MAINTENANCE ITEM 324: USE OF TICK IN LIST EXECUTE STATE MACHINE (802.1Q)

OCT. 2021

Figure 8-20—List Execute state machine

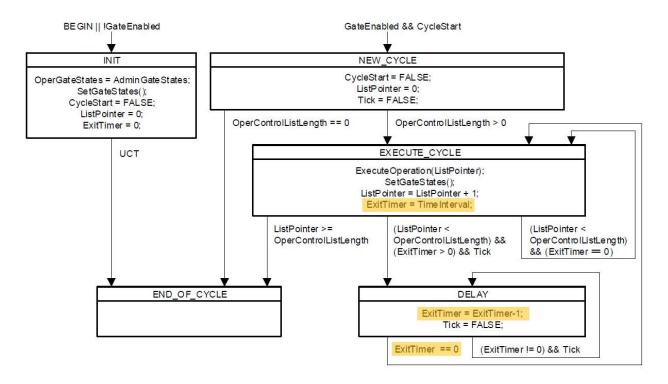
### The State Machine is mandatory!

Figure 8-20—List Execute state machine

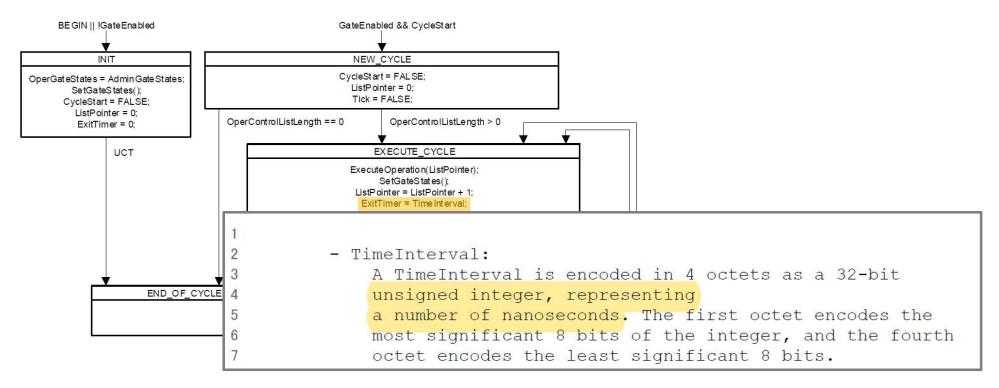
## TimeInterval is an Integer in NanoSeconds

Figure 8-20—List Execute state machine

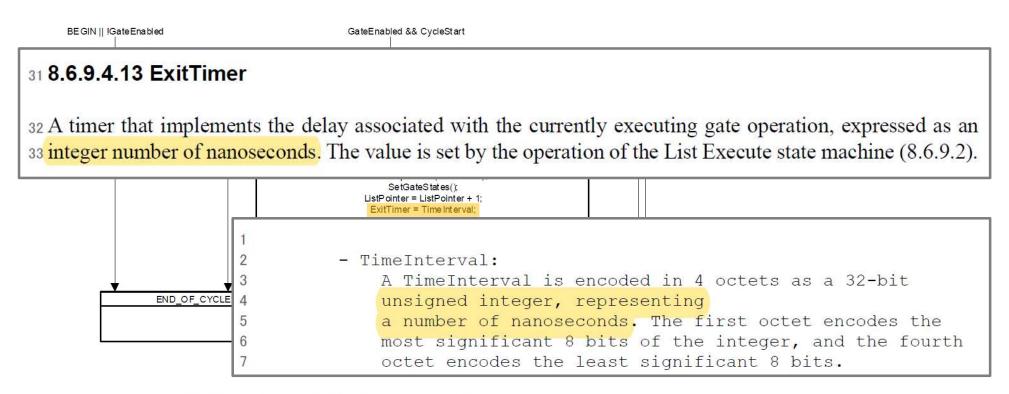
### ExitTimer is an Integer in NanoSeconds

Figure 8-20—List Execute state machine

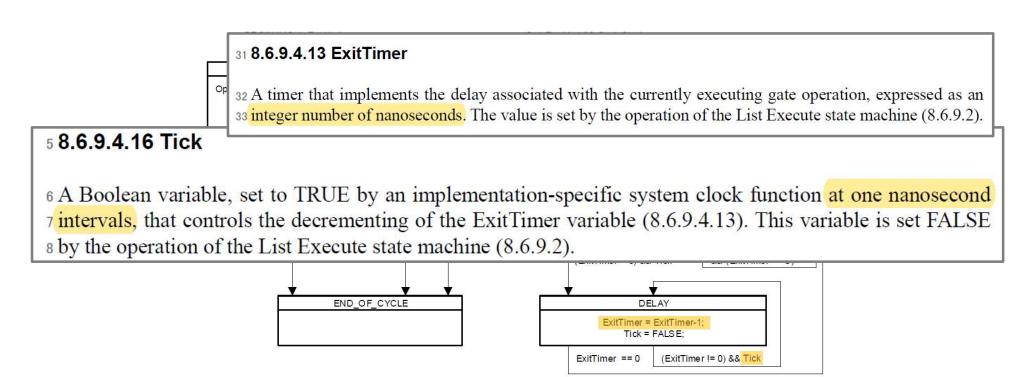
## Tick is set in integer NanoSecond intervals

# The concept of TickGranularity is not implemented
